**ADDENDUM NUMBER ONE**  
TO THE CONTRACT DOCUMENTS FOR CONSTRUCTION OF  
**ORANGE BEACH RECREATION COMPLEX**  
**NEW BASEBALL/SOFTBALL FIELD RENOVATIONS AT ORANGE BEACH SPORTSPLEX**  
CITY OF ORANGE BEACH

This addendum forms a part of the Contract Documents and modifies the Bid Documents dated May 4, 2020.

**BAHAMA SHUTTER SCHEDULE**

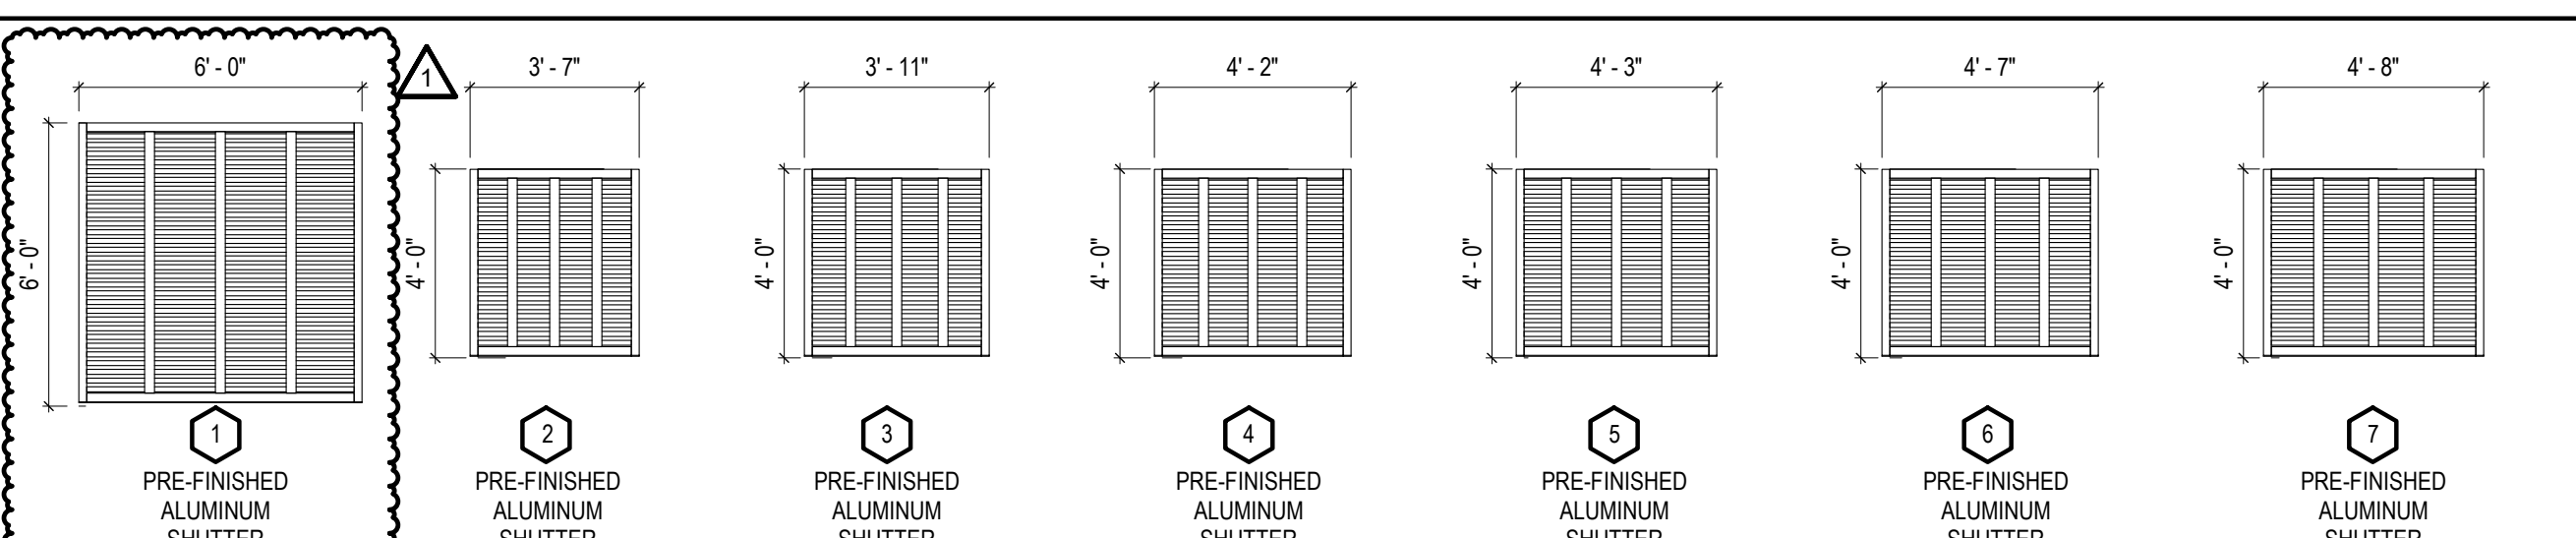
ITEM 01      SHEET A260 – DOOR SCHEDULE AND ELEVATIONS

1. Revised Shutter Schedule:
  - a. Shutter Type 1 size was changed to 6'-0" x 6'-0"

**A1** BATTING CAGE - WEST ELEVATION ENLARGED  
 G1 / A106 SCALE: 1/4" = 1'-0"

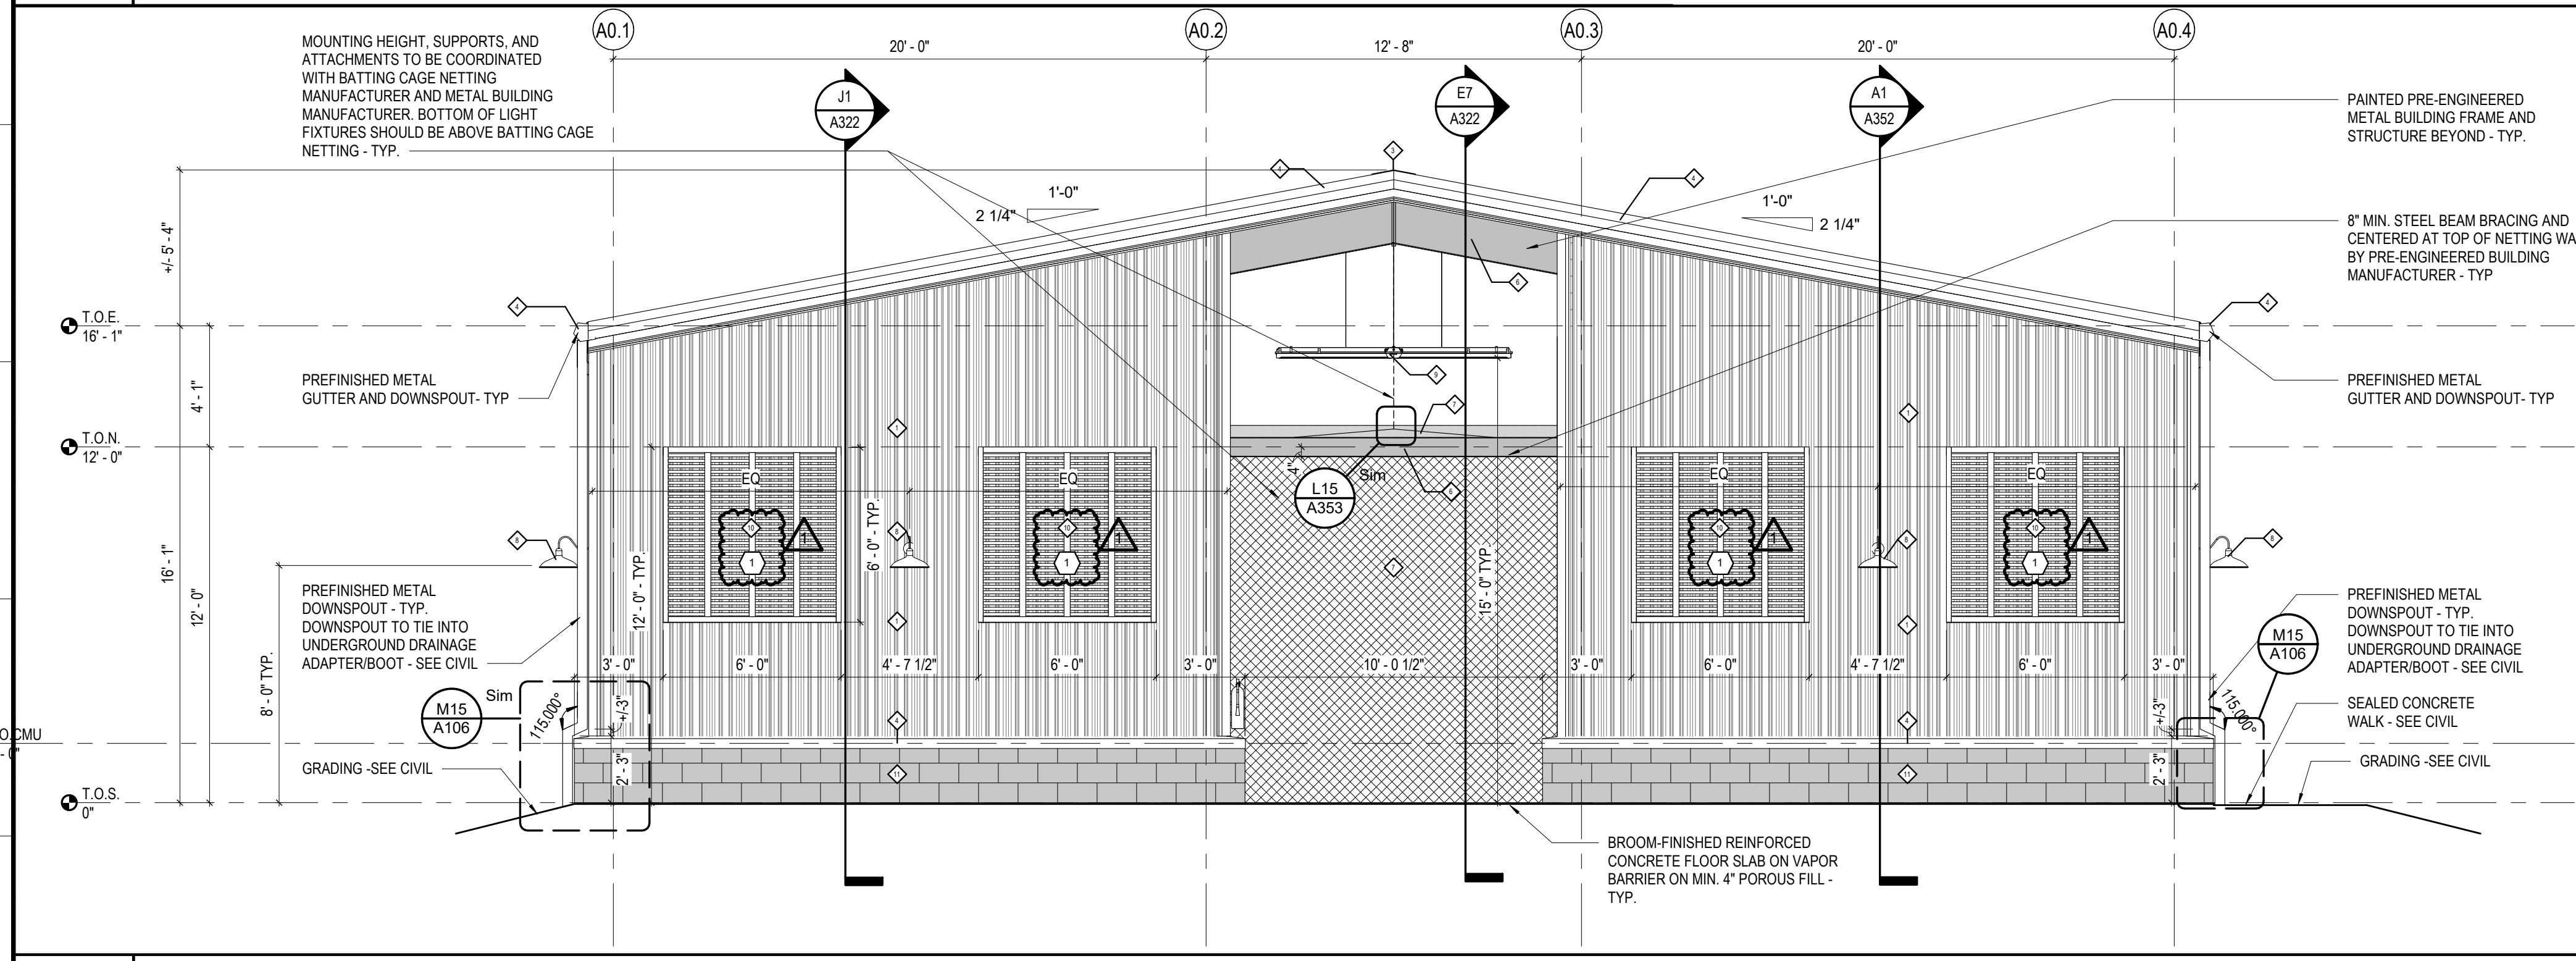
ITEM 02      SHEET A303 – EXTERIOR ELEVATIONS – BATTING CAGE (ALTERNATE #2)

1. Revised Detail A1/A303 Shutter Tags for shutter schedule were added to the elevation. Tag Shutter Type "1" WAS ADDED
